Piper Aircraft Corporation
Vero Beach, Florida, U.S.A.

SERVICE No. 860
BULLETIN

SUBJECT: Main Landing Gear Downlock Cable
Anti-Rotation Stop Replacement

SKETCH "A"

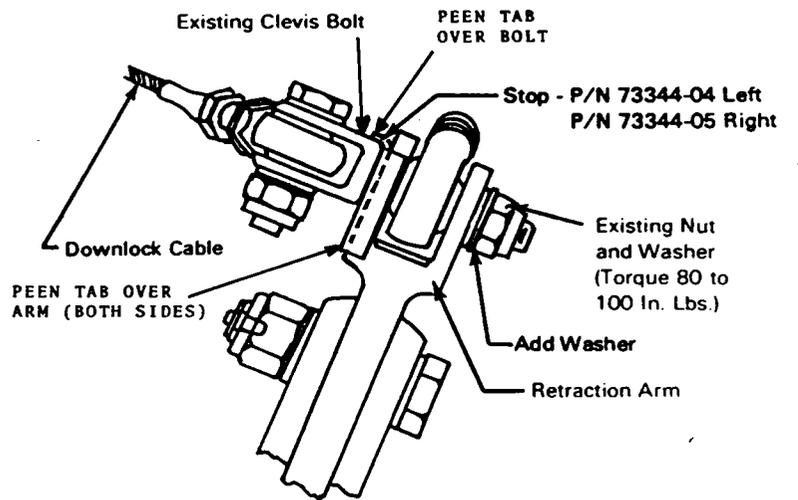
PURPOSE: It has been determined that the existing anti-rotation stop used in conjunction with the main landing gear downlock cable, as installed on certain aircraft as a field retrofit or original factory installation, can allow the cable attach clevis bolt to rotate. This in effect shortens the length of the downlock cable, preventing full engagement of the downlock hook assembly. If this condition exists and is left uncorrected, a gear unsafe condition could occur.

This Service Bulletin announces the availability of an improved anti-rotation stop which, when installed, will prevent the above described condition.

1. Place aircraft on jacks.
2. Remove nut and washer from the clevis bolt connecting the downlock cable to the retraction arm. See Sketch "A" attached.
3. Pull out the clevis bolt, remove and discard the existing anti-rotation stop, if installed.
4. Install new anti-rotation stop, Piper Part Number 73344-04 (left gear) and 73344-05 (right gear) over the bolt and reinsert bolt through the retraction arm.

5. Install an additional AN960-416 washer as well as existing washer and nut. Torque nut 80 to 100 inch pounds. See Sketch "A".
 6. Insure that tab on anti-rotation stop secures clevis bolt. See Sketch "A".
 7. Repeat procedure on opposite gear.
 8. Perform a gear function check.
 9. Remove aircraft from jacks.
 10. Make a logbook entry of compliance with PART II of this Service Bulletin.
-
